Block 16 Section 10

1.0 Context and Character

Visual Appearance Architectural Expression

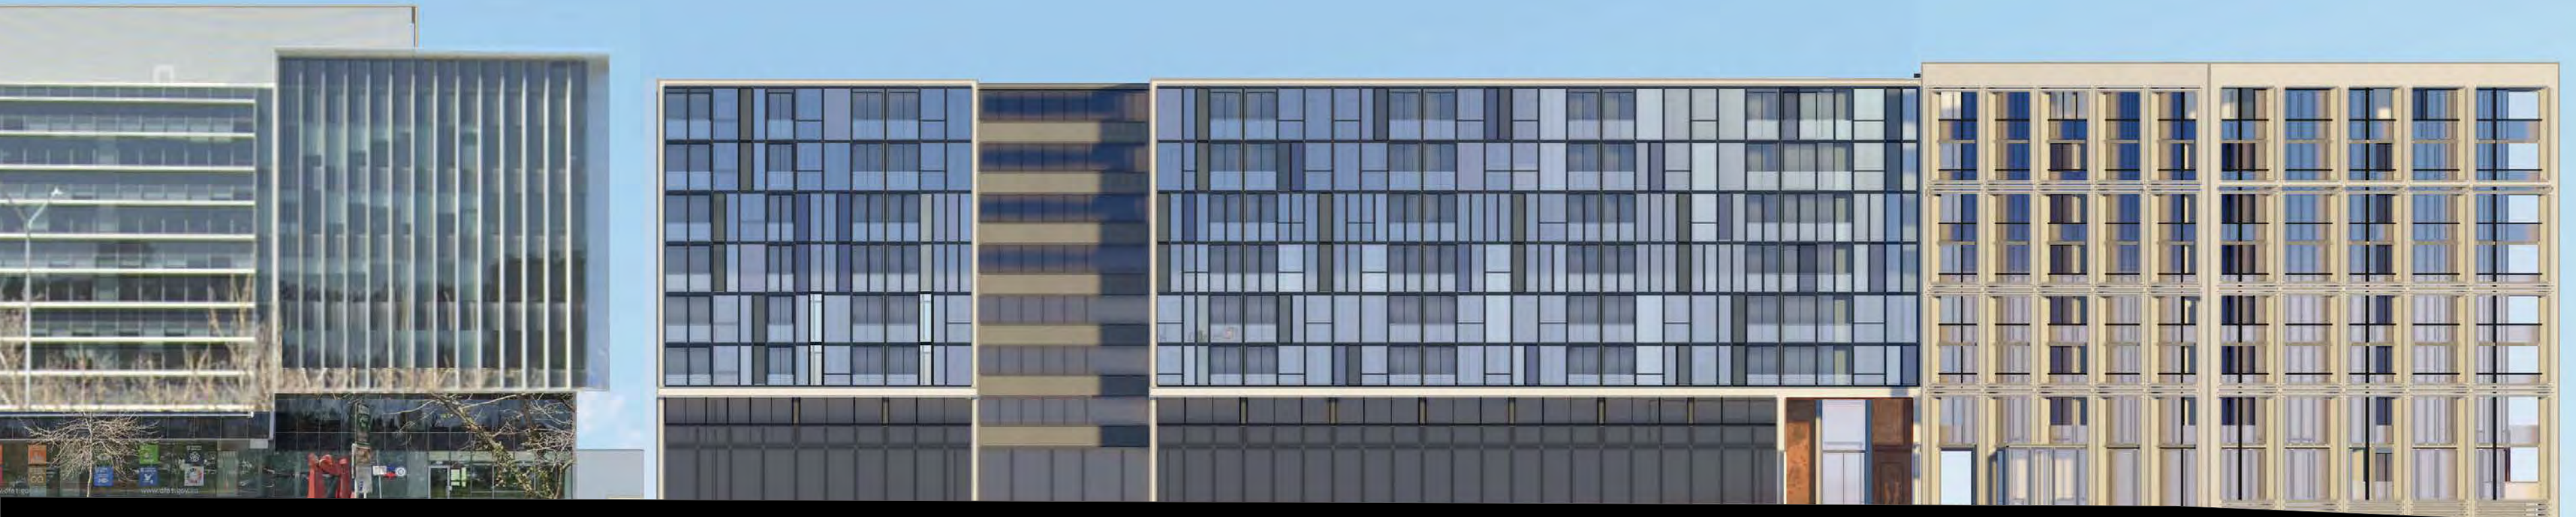
10.1 The proposed reference to both high quality public and civic architecture is considered by the Panel to be appropriate for the proposal, noting the blending of these two architectural styles in response to the building use and orientation was supported. The Panel however recommends the proponent team reconsiders appropriate passive shading measures to better respond to changing environmental challenges in place of the expansive high performance glazing. The Panel looks forward to seeing further refinement of scale and detailing in the architectural expression at the next design review session.
